DESIGN REVIEW BOARD

November 9, 2015

Case Number DRB2015-27

WATER TREATMENT PLANT FACILITY UPGRADES 1301 Lower River Road

EXHIBIT E—SITE PLAN

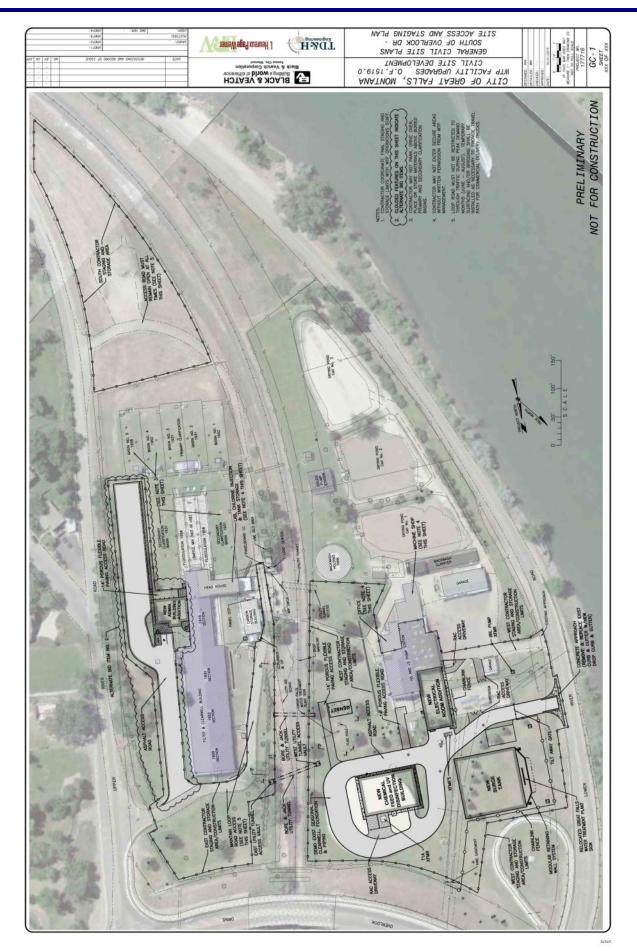
- C. The applicant shall amend the Site Plan/parking plan to allow for the safe turn-around of vehicles exiting the "asphalt access road" addition, north of the filter and clearwell building. Amended plans shall be submitted to the Planning and Community Development Department prior to the issuance of a building permit.

EXHIBIT I-LIGHTING PLAN (ADMIN. ADDITION)

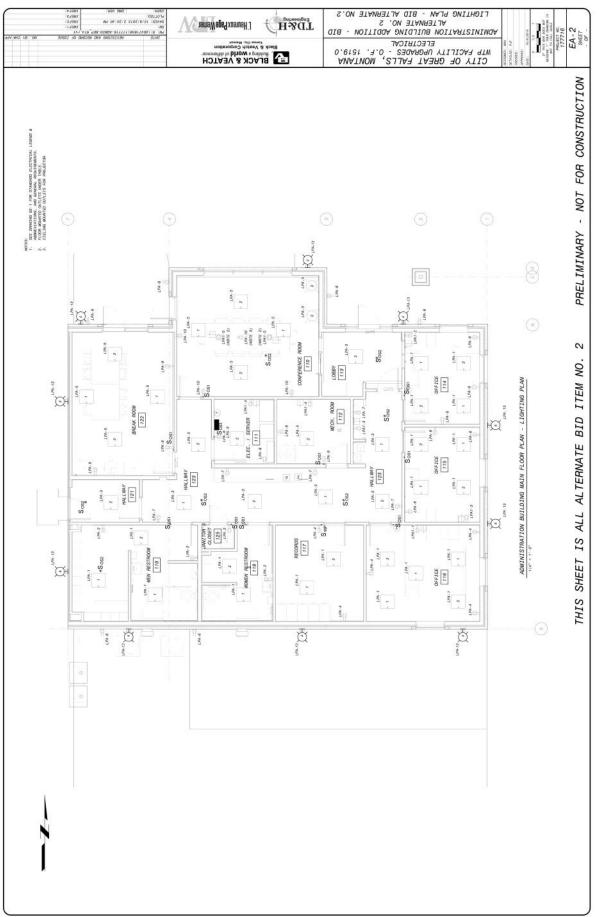
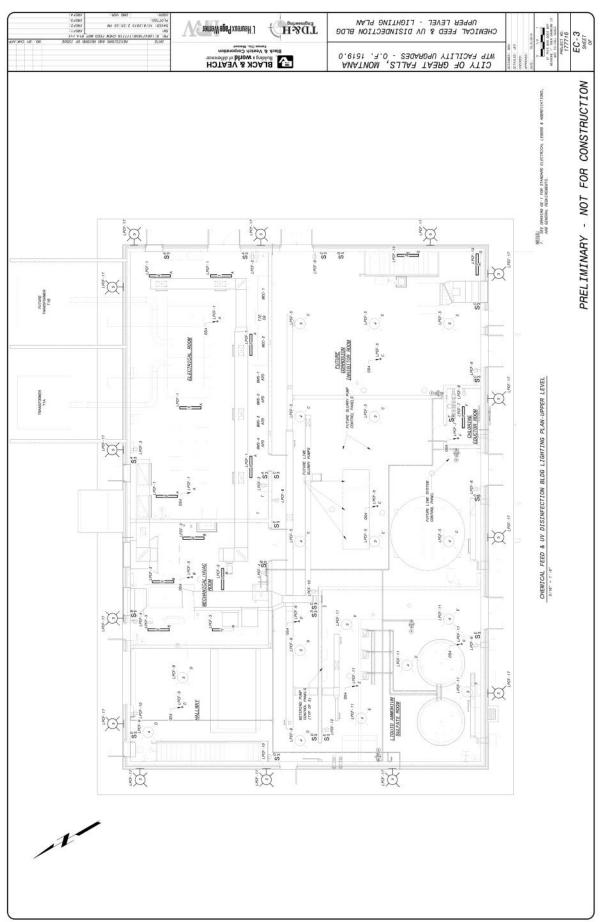
The use of wall-pack luminaires is discouraged (17.40.050). However the LED luminaire provided as part of the lighting plan is oriented downward and appears to comply with all General Standards applying to building-mounted luminaires, per the requirements of Chapter 40—Outdoor Lighting.
